## **Determination 2019/004<sup>1</sup>**

# **Regarding the decisions to refuse to issue a code compliance certificate and to issue a notice to fix in respect of a solid fuel heater installed in a house at 679 Main South Road, Islington, Christchurch**

This determination concerns an as-installed solid fuel heater and whether it was installed with the clearance behind it that was described in the manufacturer's installation instructions. The determination considers the compliance of heater and a notice to fix issued in respect of this work.

**Figure 1: Consented floor plan showing the solid fuel heater (not to scale)**

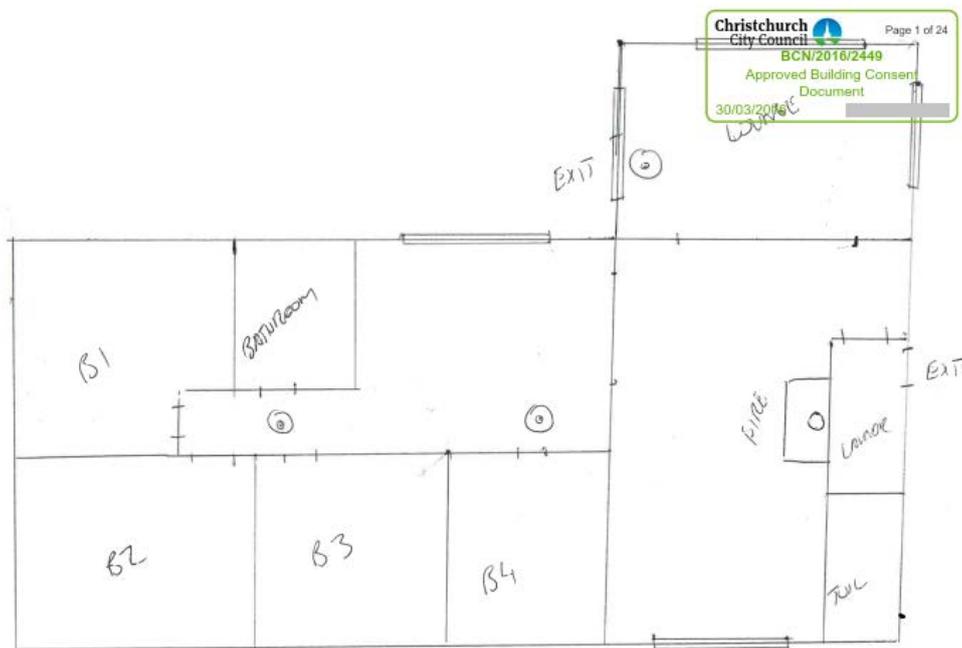
2.3 The submitted plan shows the heater being installed within the room space of the owner’s living-room, with the wall behind it unaltered. The plan did not contain any measurements showing the distance between the heater and the wall.

2.4 However, the manufacturer’s instructions specify ‘minimum safe installation clearances to combustible materials’ of 100mm, for the distance from the back of the heater to the ‘combustible wall’ behind it. The instructions also refer to how this

- 2.7 However, the heater was not installed in accordance with the consented plans. Instead, the heater is set into an alcove. The applicant advises that the alcove was constructed by a licenced building practitioner, in liaison with the applicant, at the time the heater was installed.

- 2.11 The authority inspected the building work on 27 April 2016. The inspection failed because the clearance at the back of the heater was less than 100mm. The authority also noted that the building work had not been carried out in accordance with the consented plans, and that the heater had been ‘installed into an alcove surrounded by a non-vented schist wall, with a trapped cavity’. The applicant queried this decision and the authority carried out a further inspection on 17 May 2016, which again failed for the same reason.
